ASSESSMENT REPORT

Bodangora Wind Farm Ancillary Infrastructure Modification (10_0157 MOD 2)

Figure 4: Proposed substation location

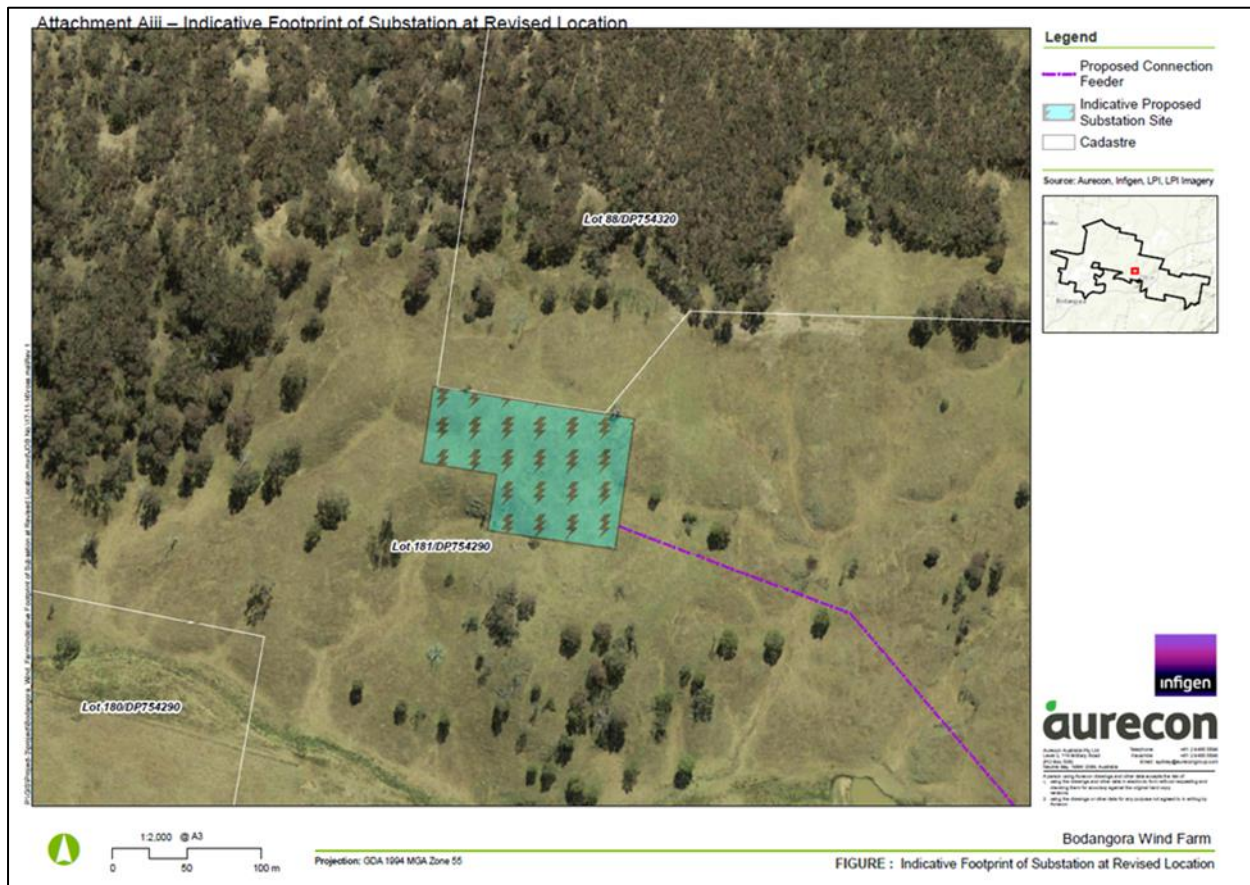
- the proposed substation location would be within an open area of grassland and would not impact any existing vegetation (refer **Figure 4**); and
- the revised transmission line alignment would avoid more vegetation than the original transmission line alignment. This is because the original alignment traversed areas of wooded vegetation and did not allow for micro-siting (ie. straight line design), whereas the proposed alignment incorporates micro-siting up to 100 m to avoid vegetation where possible (refer **Figure 5**).

OEH initially raised concerns about the lack of detailed survey effort within the proposed new transmission line corridor alignment to confirm the desktop assessment findings. Kevin Mills & Associates provided a subsequent letter response (see Appendix E) clarifying that the area traversed by the revised transmission line route had been surveyed during the original flora and fauna surveys undertaken for the project, and that based on this knowledge and desktop assessment, the proposed modification would not have a significant impact on native flora and fauna.

Following further consultation with OEH, it was agreed that detailed vegetation mapping of the transmission line corridor should be undertaken prior to construction to identify the location of any endangered ecological communities or other threatened species and enable impacts to be avoided (where possible) through micro-siting. The Department has included this requirement in the amended conditions of approval.
